BROWNS FERRY NUCLEAR PLANT UNIT 1

BROWNS FERRY NUCLEAR PLANT UNIT 2

SAFETY EVALUATION BY THE OFFICE OF NUCLEAR REACTOR REGULATION
SUPPORTING AMENDMENT NO. 1⁷ TO FACILITY OPERATING LICENSE NO. DPR-33
AND AMENDMENT NO. 1⁴ TO FACILITY OPERATING LICENSE NO. DPR-52
BROWNS FERRY NUCLEAR PLANT UNITS 1 AND 2
TENNESSEE VALLEY AUTHORITY
DOCKET NOS. 50-259 AND 50-260

NOTICE OF ISSUANCE OF AMENDMENTS TO FACILITY
OPERATING LICENSES

FIGURE 1 Plug Installed in Core Support Plate

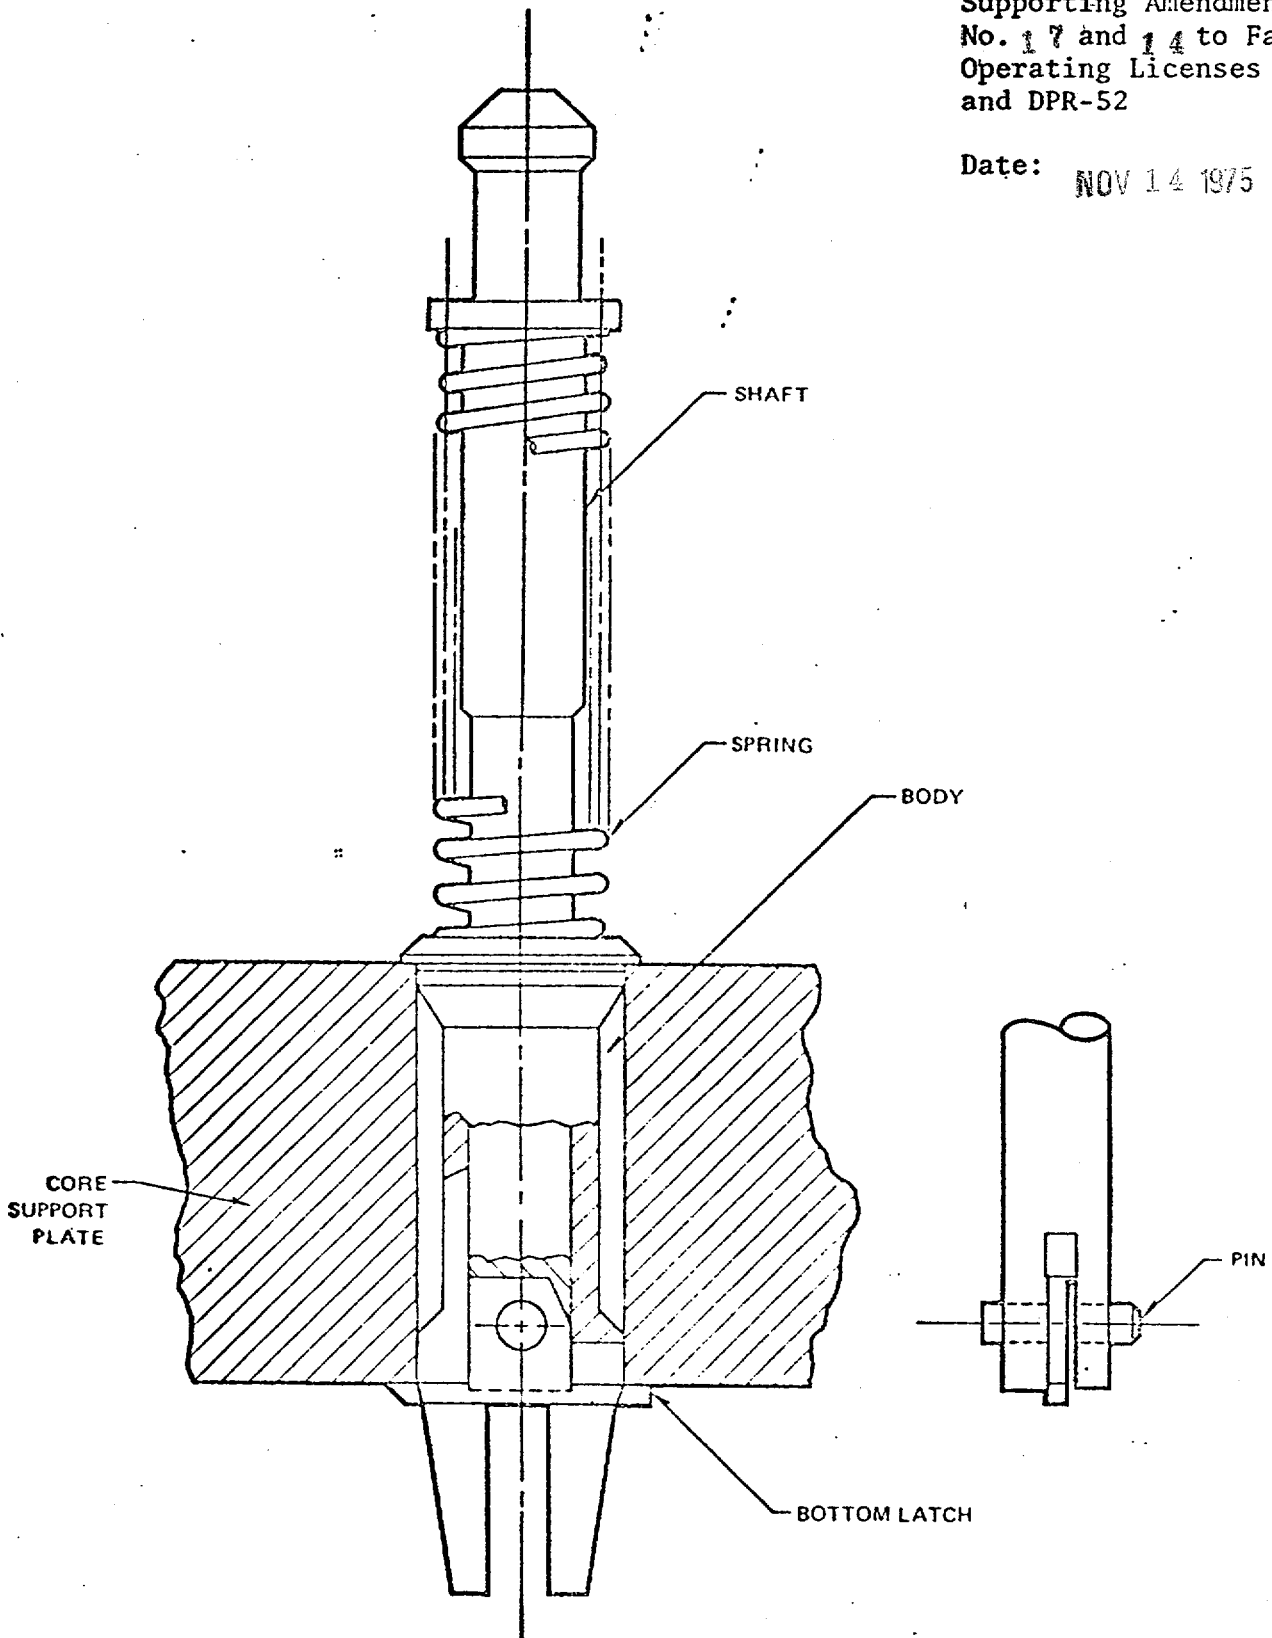
The plug consists of five basic parts, as shown in Figure 1. Identical plugs have previously been installed at Vermont Yankee, Pilgrim, Cooper, and Duane Arnold. The body provides a means of guiding the device into the bypass flow holes as well as a shoulder to support the plug and form a seal against water flow. The shaft extends through the body. A knob

is provided at the top of the shaft to provide a means of grabbing the plug during installation and extraction. At the bottom, the latch is attached to the shaft by a pin. The latch is free to rotate during installation. The spring acts against the body and shaft during normal operation to provide the force necessary to offset the pressure differential acting on the body.

During installation, the plug has its latch rotated 90 degrees from its installed position and withdrawn and locked in the body. The shaft is gripped by the installation tool, and the plug is inserted into the bypass flow holes. The body engages the rim of the hole. The shaft is pushed to its full extension, thus lowering and unlocking the latch below the underside of the core plate. The latch then rotates 90 degrees and bears on the bottom of the core plate. After insertion, the plug is pulled with about 30-pound force to test the placement. All fuel has been removed from Units 1 and 2. Therefore, the plugging operation involves no risk of fuel assembly damage and fission product release.

The plug can be removed by gripping the top of the shaft with an extracting tool and applying a force of about 500 pounds. The latch's legs will be plastically deformed and the entire plug withdrawn. The plugs previously installed at Vermont Yankee were removed with no abnormalities or loose pieces reported. The force required for removal varied from 500 to 1300 pounds.

Based on a review of the design, the installation methods and the previously successful operating experience at Vermont Yankee, Pilgrim, and Duane Arnold, we conclude that the plugs can be installed without damage to core components, that they will not fail during operation so as to result in loose parts in the core or result in unplugging of the bypass flow holes, and that they can be removed, if necessary, without damage to core components. The modification is thus reversible.

Accordingly, we conclude that the installation of the plugs is acceptable. The present license amendments, which authorize plugging of the core lower support plate bypass holes, do not authorize operation of the facility with these holes plugged. Such operation is not presently intended by the licensee and would be the subject of a separate licensing action if such operation is proposed. It is presently TVA's intention to complete the drilling modification, subsequent to our approval, prior to return to operation. This modification also will be the subject of a separate licensing action.
